Development Management Sub Committee

Wednesday 8 September 2021

**Application for Planning Permission 21/00381/FUL
At Powderhall Bowling Green, Broughton Road, Edinburgh
Phase 2 of 3 phase masterplan at Powderhall. Phase 2 is the former Bowling Green Site, this area is a mixed use development, to include an early years nursery, accessible housing for independent living for those aged 55 and over, outdoor amenity space for Broughton Primary School and associated landscaping, including new public entrance square and enhanced landscaping works to St Mark's Path.**

Summary

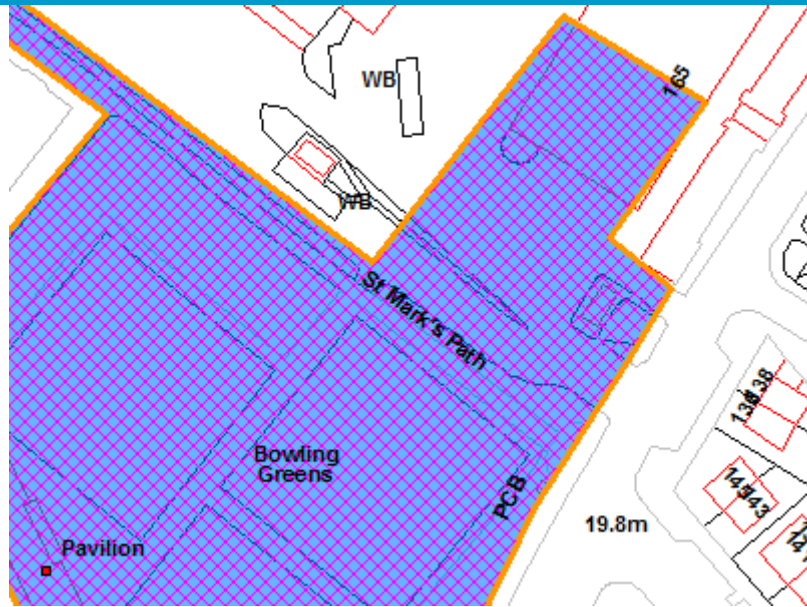
- The proposed floor build-up between the nursery and the residential flats consists of 22 mm chipboard on 19 mm plank on 100 mm timber battens with an integral resilient layer, on 100 mm concrete screed on 150 mm normal weight pre-cast concrete slab, with 1 layer of 12.5 mm plasterboard and 1 layer of 19 mm plank installed at approximately 100 mm below the underside of the concrete slab, and 100 mm mineral fibre insulation in the cavity. The floor build-up is shown in Figure 5 of the NIA.

- Glazing units with a minimum specification of 10mm/16mm (argon air gap)/6 mm double glazing shall be installed for the external doors and windows of residential units located in 'zone 1' as illustrated in figure 3.

- Glazing units with a minimum specification of 8mm/16mm (argon air gap)/4 mm/16mm (argon air gap)/4mm triple glazing shall be installed for the external doors and windows of residential units located in 'zone 2' as illustrated in figure 3.

shall be carried out in full and completed prior to the development being occupied.
